FCO CA13418: EMC Fix For Trendsetter CL/AL/NEWS with TH1.7

Internal document number: 719-00957A Rev A

Machines affected All GMCE Trendsetter CL, AL and NEWS devices with TH1.7

Figure 1: Filter cable assembly installed

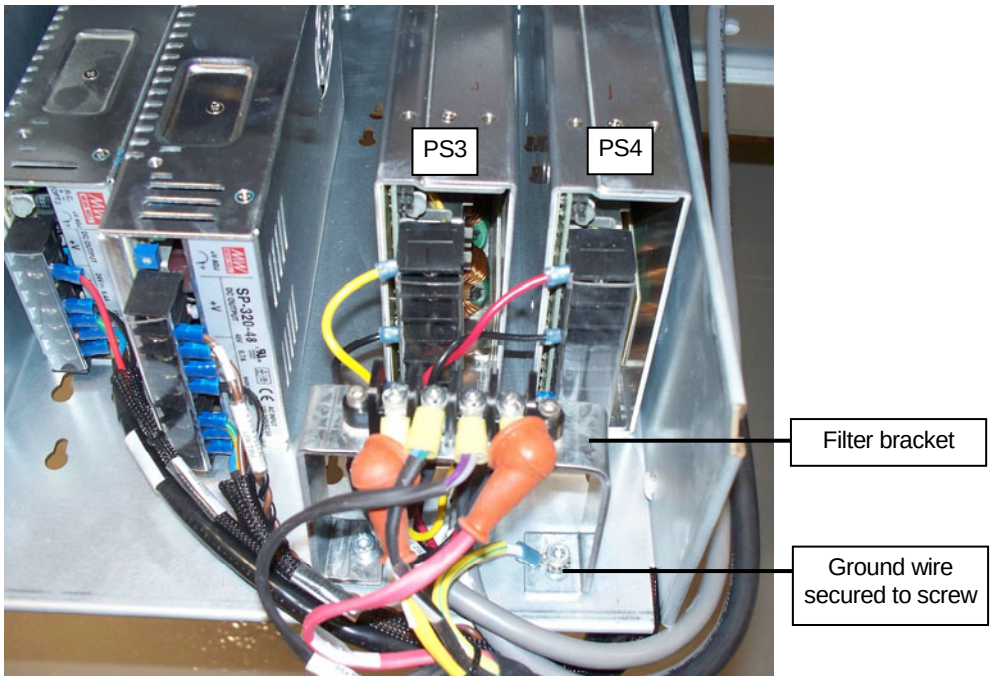
3. Remove the thermal head DC power cables from PS3 and PS4.
4. Attach the yellow and black wires from the filter cable to PS3, as shown in Figure 1.
5. Attach the red and black wires from the filter cable to PS4, as shown in Figure 1.
6. Mount the filter bracket onto the power supply tray with the supplied M5*12 sock cap screws and lock washers. Secure the ground wire under the screw on the right side of the bracket. See Figure 1.

Figure 2: Filter bracket terminals

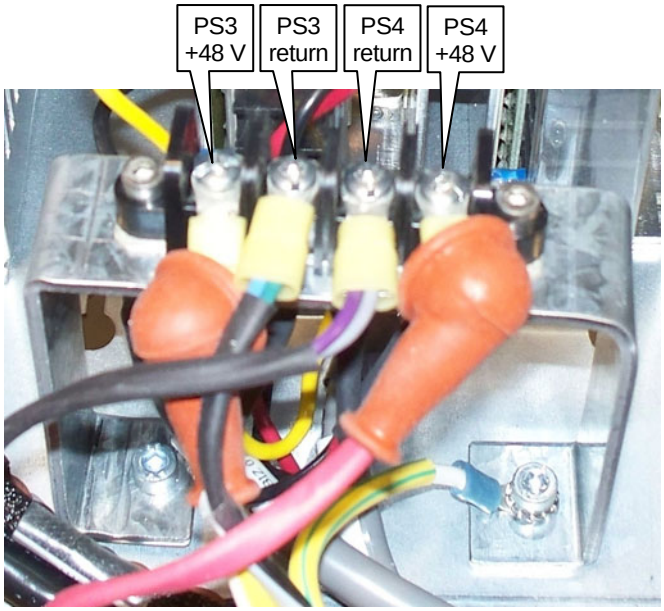
7. Attach the PS3 thermal head cable to the filter terminal, as shown in Figure 2. The leftmost terminal is for PS3 +48V, and the terminal immediately to its right is for PS3 return. Check the labeling on the cable.
8. Attach the PS4 thermal head cable to the filter terminal, as shown in Figure 2. The rightmost terminal is for PS4 +48V, and the terminal immediately to its left is for PS4 return. Check the labeling on the cable.

Figure 3: Drum motor filter cable installed

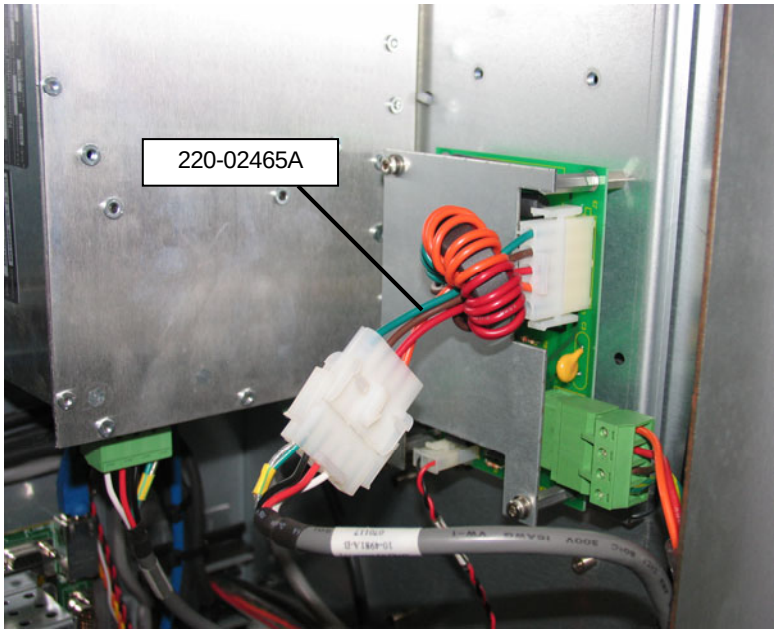
9. Remove the drum motor power cable from drum brake board connection J3.
10. Install motor filter cable assembly 220-02465A between the drum brake board J3 and the drum motor power cable, as shown in Figure 3.
